Job No. 195345

April 24, 2024

Re: Response to CGS Review Comments dated August 4, 2022 and October 26, 2022
Lots 1-39, Falcon Meadows at Bent Grass, Filing No. 4
El Paso County, Colorado

SHEET No.
FIG-1

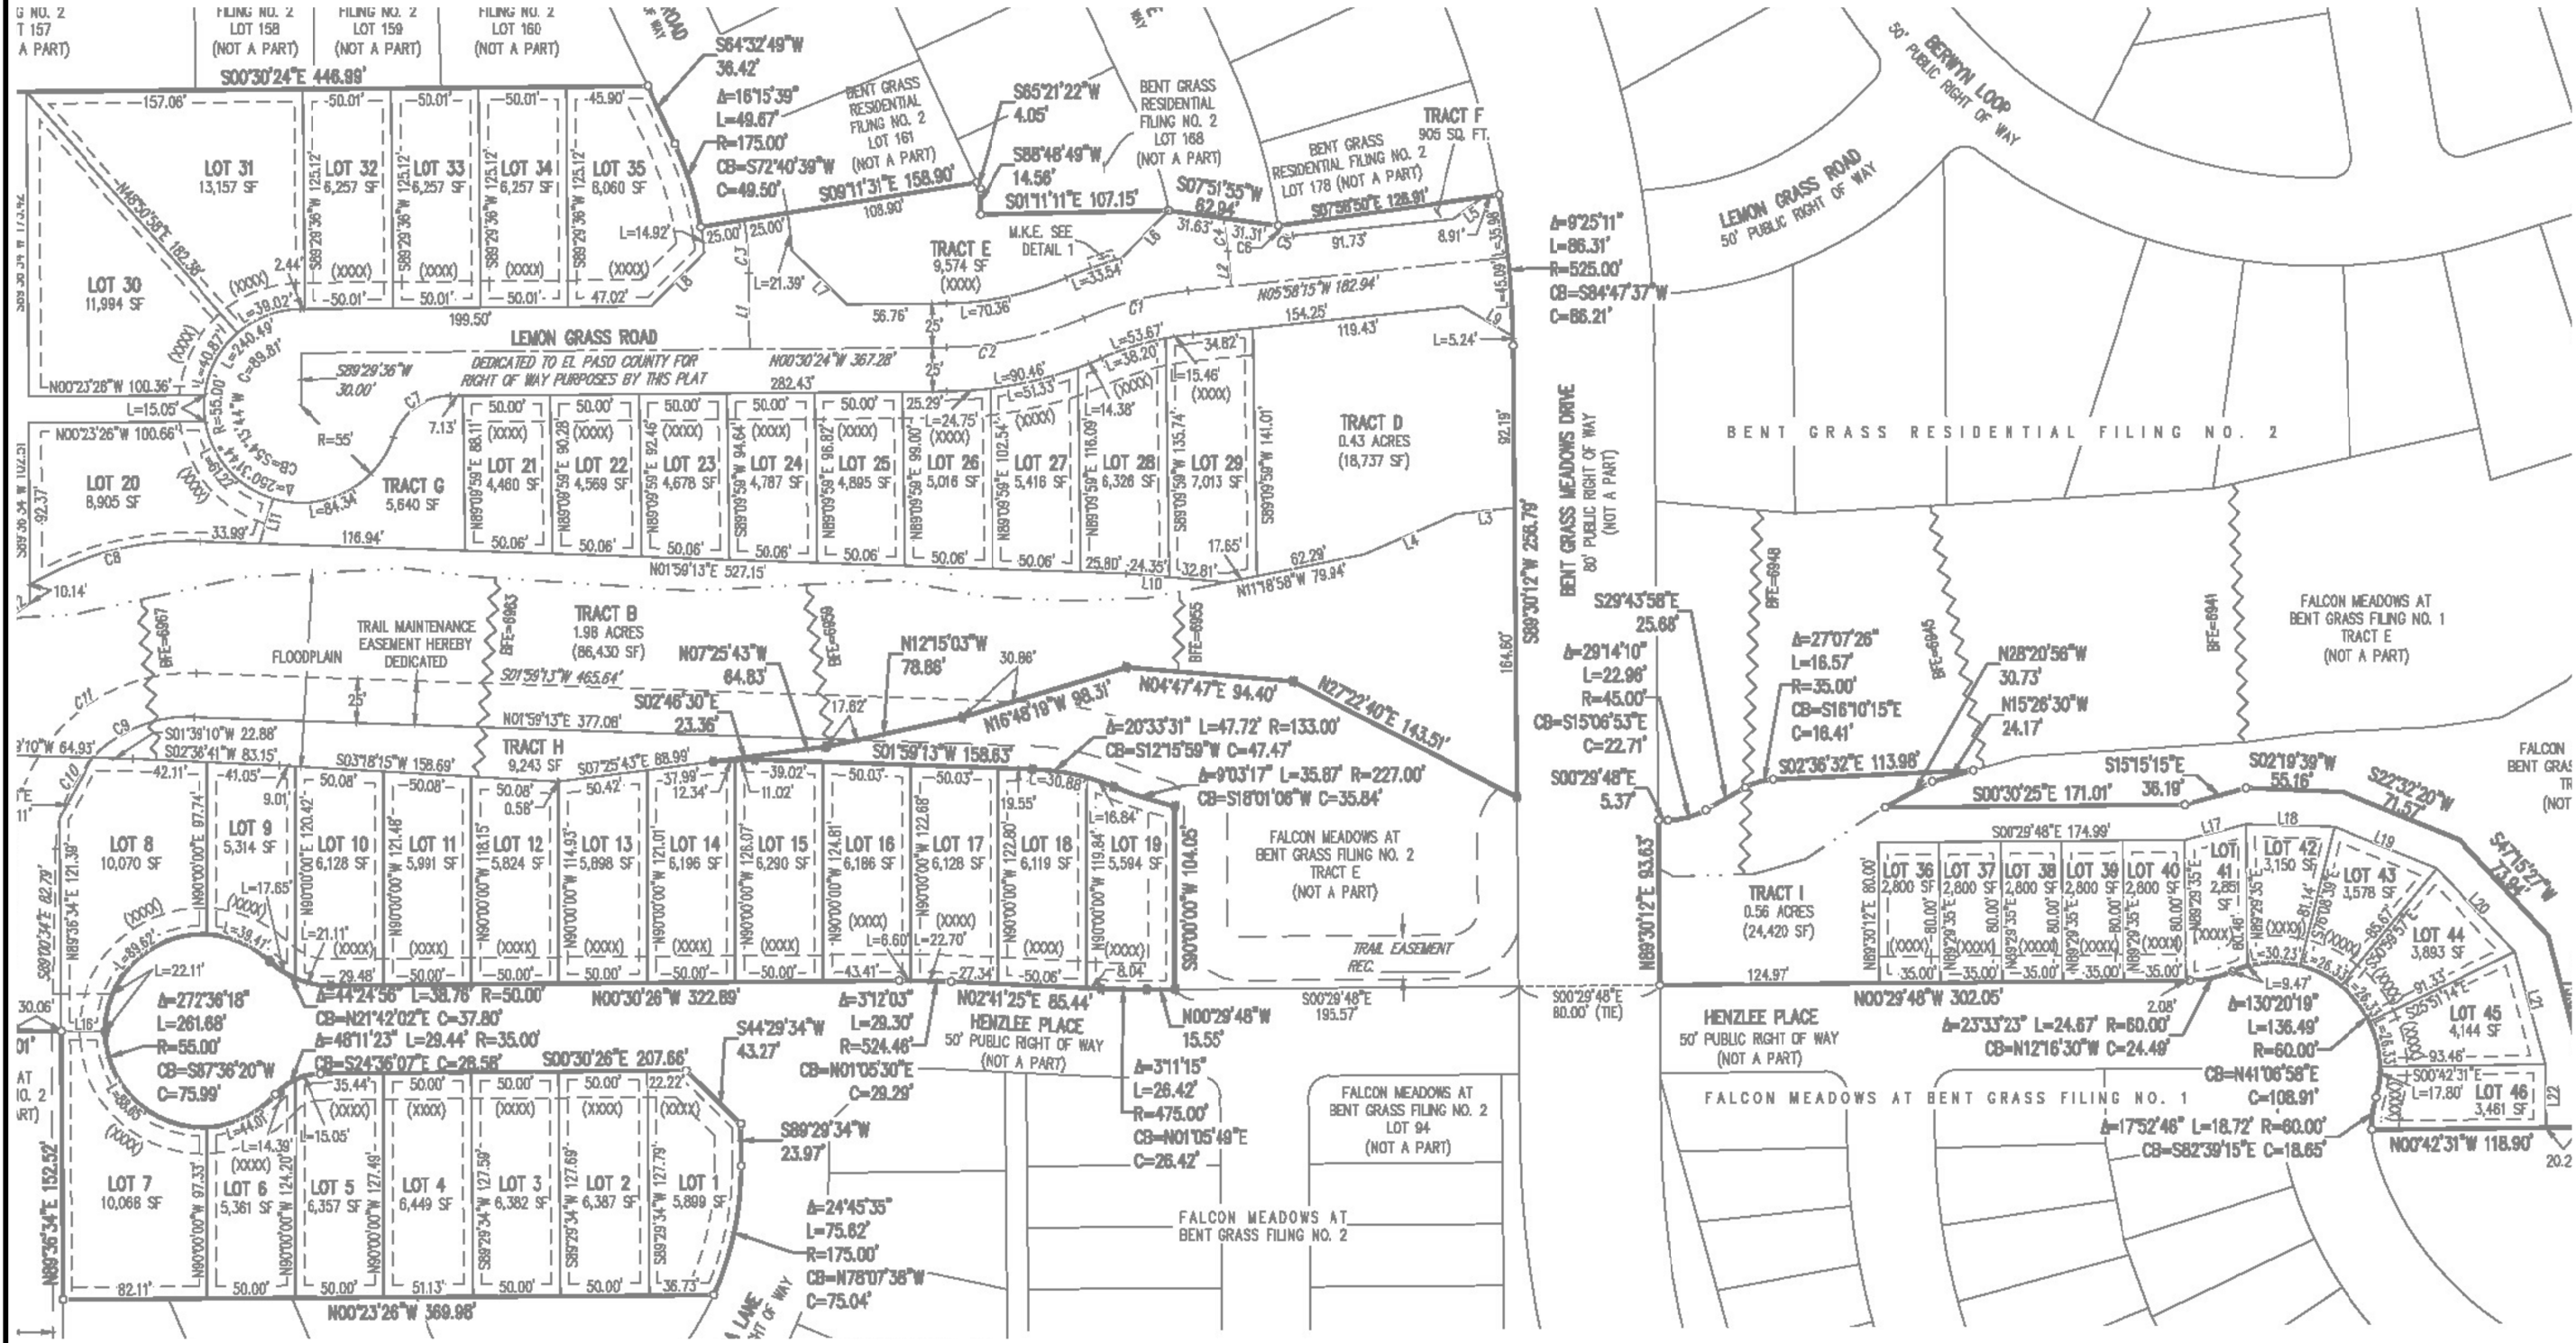
As stated on page 14 in RMG’s soil and geology study (Rocky Mountain Group (RMG), Revised December 3, 2021), “In areas where groundwater is anticipated to be within 14 feet of the original ground surface, Challenger Homes is proposing the use of non-basement foundations.” RMG’s study includes test holes and specific recommendations for Filing No. 1 through 3. The letter of intent (N.E.S., Inc., Revised October 2022) states, “The overall Bent Grass development restricts several lots to non-basement construction. However, all 39 lots in Falcon Meadows at Bent Grass Filing No. 4 were not specified for non-basement construction. Individual site-specific soils and geology studies will verify if basement construction is feasible for each lot.” CGS disagrees with verifying basement construction feasibility during individual site-specific studies.

The *Soils and Geology Study* completed for Falcon Meadows at Bent Grass was completed for the entire development. Since the issuance of this report the subdivision has been split into 4 filings. Filing No. 4 was included in the 2021 study but not identified as Filing No. 4 at that time. The subject lots

have since been allocated to Filing No. 4 and renumbered as lots 1-39. An updated Development Plan showing just Filing No. 4, is presented in Figure 1.

All 39 lots included in Filing No. 4 are to be stiffened slab-on-grade foundations with no below ground habitable or inhabitable space. It is our understanding basements are not to be utilized in Filing No. 4.

SHEET No. FIG-2

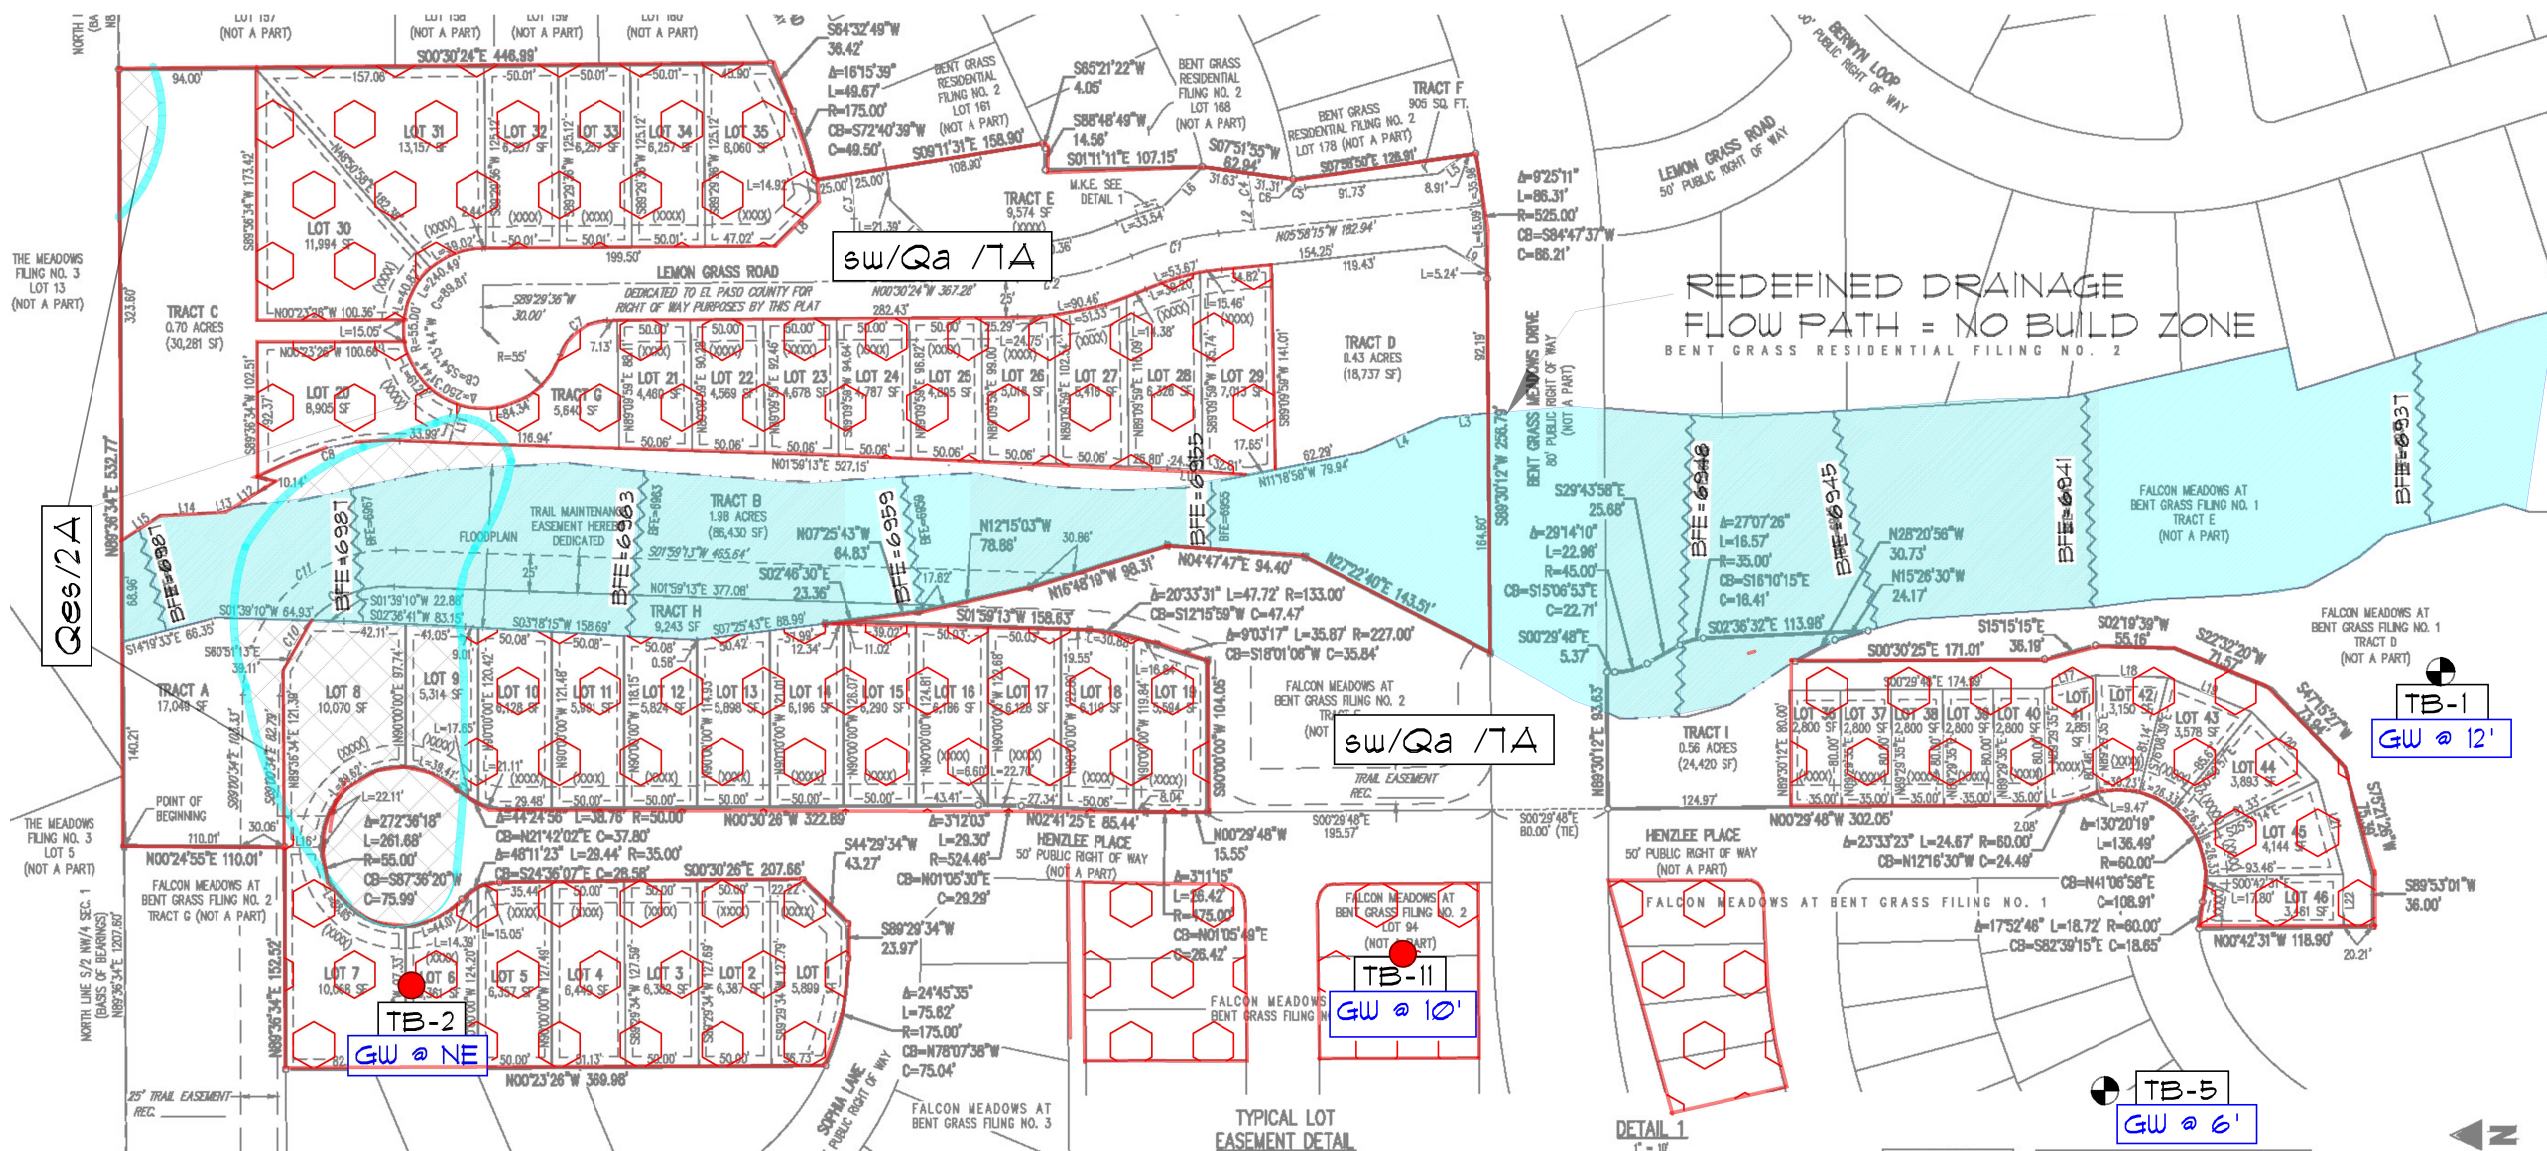
CGS recommends a site-specific study for Filing No. 4 that includes an updated Engineering and Geology Map illustrating lots to be restricted to non-basement construction. If basements are planned within Filing No. 4, CGS recommends the county require groundwater monitoring/observation to verify that proposed floor levels are at least three feet above maximum anticipated groundwater levels (and maintained year-round) or groundwater is greater than 14 feet below the original ground surface. This monitoring/observation program should be conducted immediately (prior to final plat approval) and before the installation of public infrastructure to determine if basements are feasible, to design detention ponds, and understand the effect groundwater will have on public infrastructure. Groundwater levels typically rise after development, and measurements of groundwater variations provide a basis for anticipating future groundwater levels.

This letter includes an updated Engineering and Geology Map, Figure 2 illustrating the lots be restricted to non-basement construction. All other recommendations within the referenced *Soils and Geology Study* report are still valid.
